Model type:
LI670DUO

Commercial code:
F029513

Notices

n1045069: Modification of racks and dispenser lid on EVO3 dishwashers

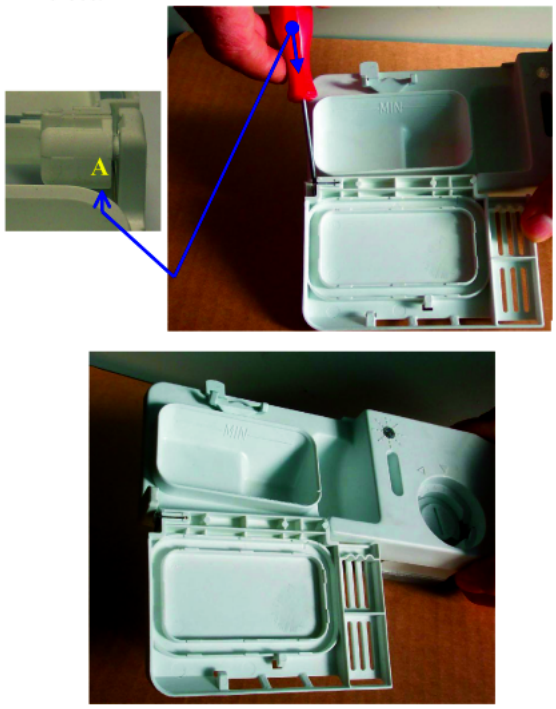
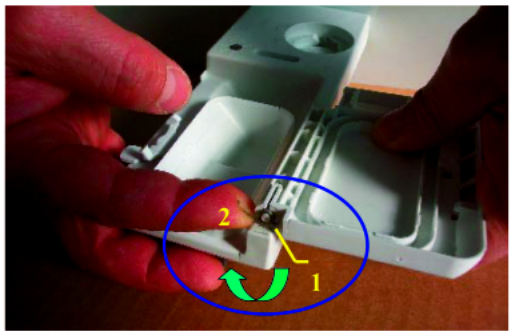
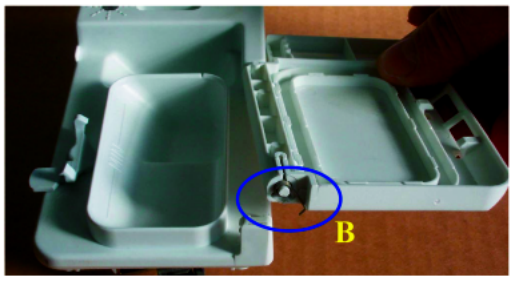
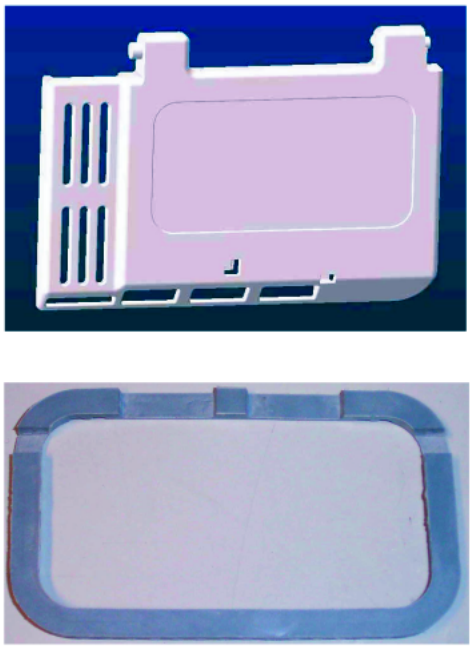
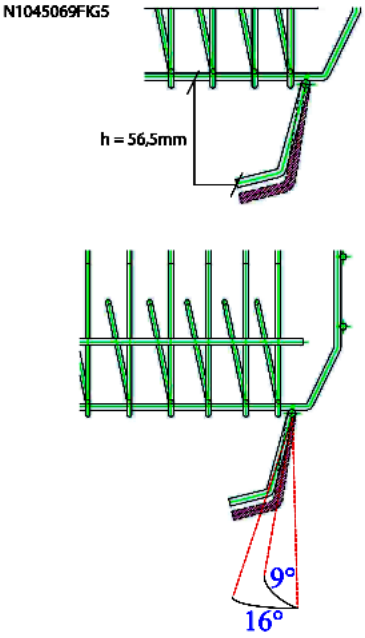
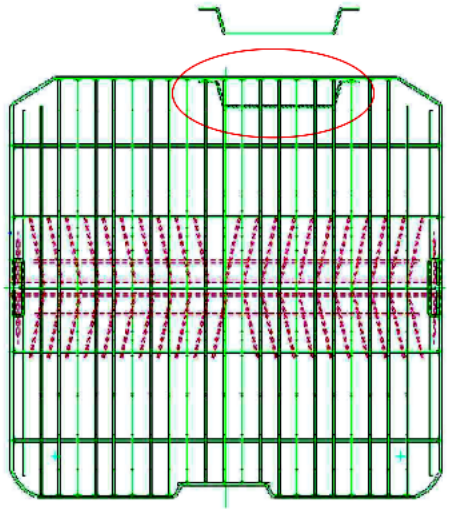
To obtain better dissolving of the detergent during the wash cycle, the following modifications have been made to EVO3 dishwashers:
- new dispenser lid, replacement code 098134 (see figure N1045069FIG4) created;
- upper racks modified with lid catch angle changed from 9° to 16° (see figure N1045069FIG5);
- MultiSystem lower racks modified with insertion of a spacer wire at the electric dispenser (see figure N1045069FIG6).

Lid installation instructions:
1) prise the lid out of the dispenser seat using a small screwdriver at point A (figure N1045069FIG1);
2) replace the lid, checking that release spring B (figure N1045069FIG2) is in place; before fitting the new lid load the spring from position 1 to position 2 (figure N1045069FIG2);
3) fit the lid in its special seat and check for correct operation (figure N1045069FIG3).
Lid closing may be harder for the first few cycles after replacement, due to settling of the material.

The upper and lower racks have the same spare part codes as the premodification items; Replacements Warehouse stocks have been replaced.

N1045075FIG1

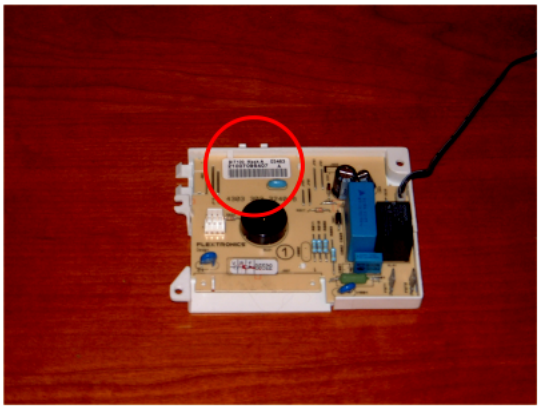
BIT 100 "P2" TIMER (210097637.XX) Service code 097431 has been replaced with BIT 100 "E2" TIMER (210097877.02) Service code 097481.
BIT 100 "D" TIMER (210093806.XX) Service code 095281 has been replaced with BIT 100 "E2" TIMER (210097877.02) Service code 097481.

Replacement of Service codes 097431 and 095281 with 097481 is only possible with BIT 100 "E2" TIMER card code 210097877.02.

The card code is printed on an adhesive label located on the box or on the card itself (illustration N1045075FIG1).

Stocks of Service code 097481 in the Spare Part Warehouse have been replaced with card 210097877.02.

N1045083FIG1

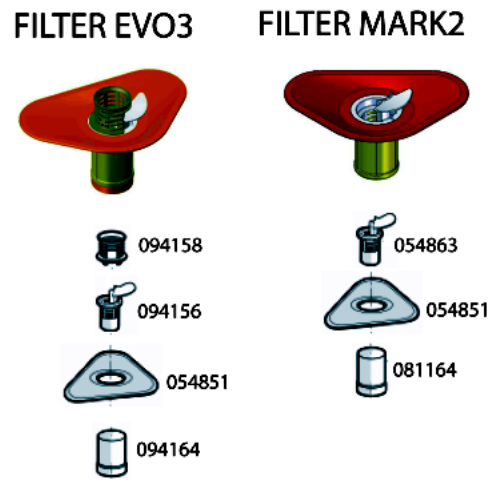
All dishwasher models affected by this modification have been equipped with the items listed below, in order to solve the drain pump clooging problem.

Introduction of:
Cylindrical plastic filter code 081164
Central filter code 054863

Elimination of:
Cylindrical plastic filter code 094164

Central filter code 094156
Central filter grid code 094158

The modification has been introduced progressively, starting from serial no. 40516.0001.

n1045085: Introduction of new litre counter turbine integrated on air-break.

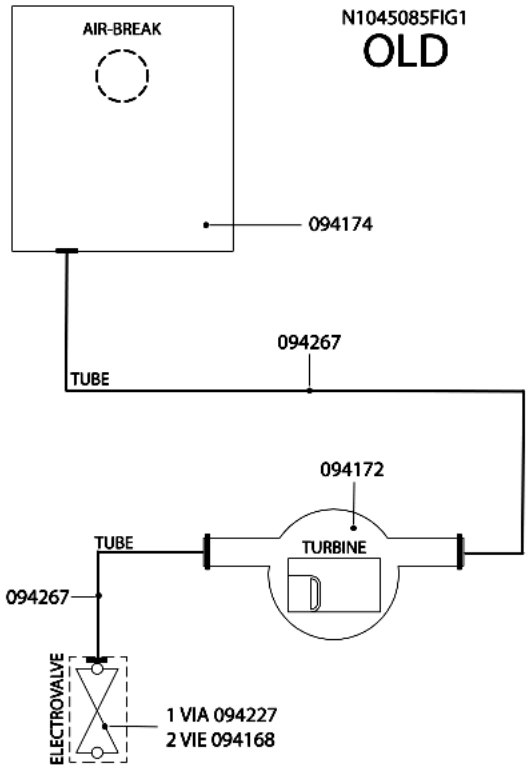
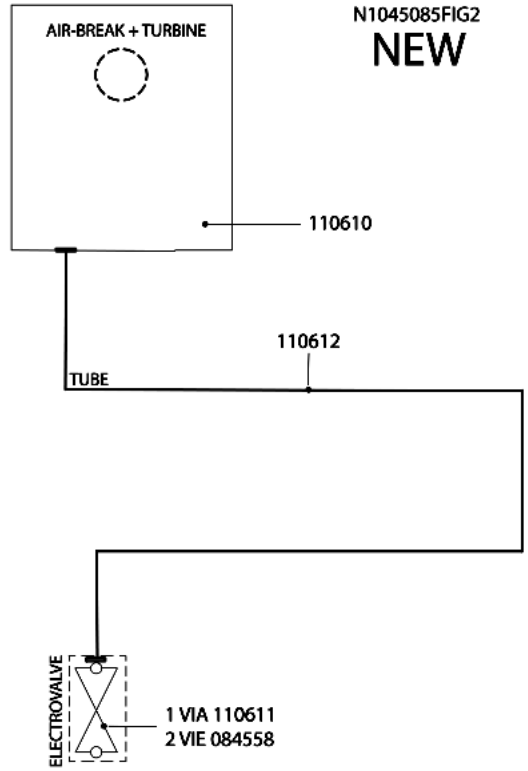
All dishwashers affected by this note have been equipped with a new litre counter turbine on the air-break.
Picture N1045085FIG1 illustrates the premodification structure, picture N1045085FIG2 the new structure.

AIR-BREAK:
new 110610;
premodification 094174;
the new item features a new integrated litre counter turbine and its water supply hose has a smaller diameter.

LITRE COUNTER TURBINE code 094172 has been eliminated.

SOLENOID VALVES:
new:
1-WAY code 110611;
2-WAY code 084558(Rohs 143737);
premodification:
1-WAY code 094227;
2-WAY code 094168;
the new solenoid valves have a smaller diameter drain hose fitting.

HOSES:
new solenoid valve hose/air-break code 110612;
premodification turbine hose/air-break code 094267;
premodification solenoid valve hose/air-break code 094267;
the new hose has a smaller internal diameter.

WIRING:
the litre counter turbine connecting cable is longer, but since the connector is the same, the new item can be used in place of the

Affected models with related modification introduction serial numbers:
BCI 450 - 30386 s/n 41001.0001;
BFI 620 - 30708 s/n 41001.0001;
BFI 680 - 30715 s/n 40902.0001;
BFV 620 B - 30718 s/n 41001.0001;
BFV 620 K - 30717 s/n 41001.0001;
BFV 620 W - 30719 s/n 41001.0001;
BFV 620 X - 30720 s/n 41001.0001;
DI 6 - 29930 s/n 41001.0001;
DI 620 A - 29932 s/n 40830.0001;
DI 620 - 29931 s/n 41001.0001.
DI 620 UK - 30351 s/n 41001.0001;
DI 630 A - 30369 s/n 41001.0001;
DV 620 BK - 29927 s/n 41001.0001;
DV 620 BK UK - 30349 s/n 41001.0001;
DV 620 K IX UK - 30350 s/n 41001.0001;
DV 620 WH - 29928 s/n 41001.0001;
DV 620 WH UK - 30348 s/n 41001.0001;
DV 630 A BR - 30695 s/n 40830.0001;
DV 630 A IX - 30693 s/n 40830.0001;
DV 630 A WH - 30694 s/n 40830.0001;
DV 640 A IX - 30368 s/n 40830.0001;
DV 650 A IX - 30696 s/n 40830.0001;
DV 650 A WH - 30697 s/n 40830.0001;
DV 670 A BR - 30701 s/n 40830.0001;
DV 670 A IX - 30699 s/n 40830.0001;

N1045093FIG1
NEW FLAP UPPER BASKET SAT CODE 114799

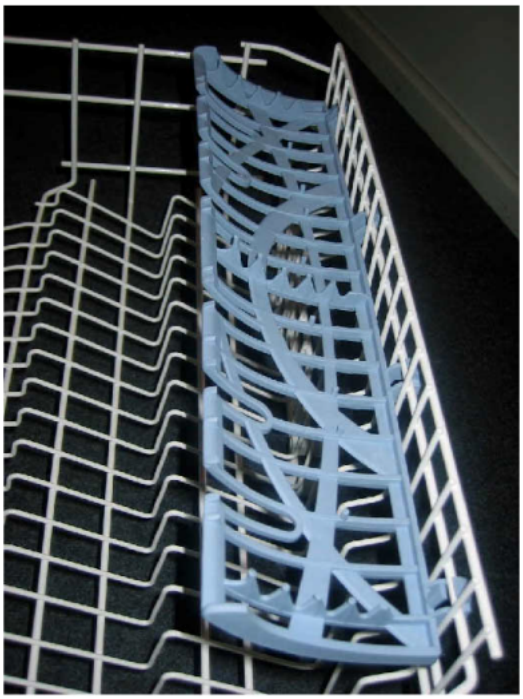
From serial no. 41109.0001 all models affected by this bulletin feature a modification of the folding shelf to upper basket coupling system.

This modification called for alteration of the relative baskets: the distance between the wire on which the folding shelf is attached and the wire below it has been increased from 9.5 mm to 17 mm, as shown in the attached image.
The altered folding shelves are not interchangeable and cannot be installed on premodification baskets: in the case of service interventions on product with serial number prior to 41109.0001 the entire upper basket must be replaced.
The baskets are reciprocally interchangeable and are managed as assemblies complete with their accessories, inclusive of folding shelves.

UPPER BASKET LIGHT BLUE FOLDING SHELF
new 114799 - premodification 094140.

UPPER BASKET ASSEMBLIES
new 115001 - premodification 094139;
new 115002 - premodification 094222;
new 115003 - premodification 094233.
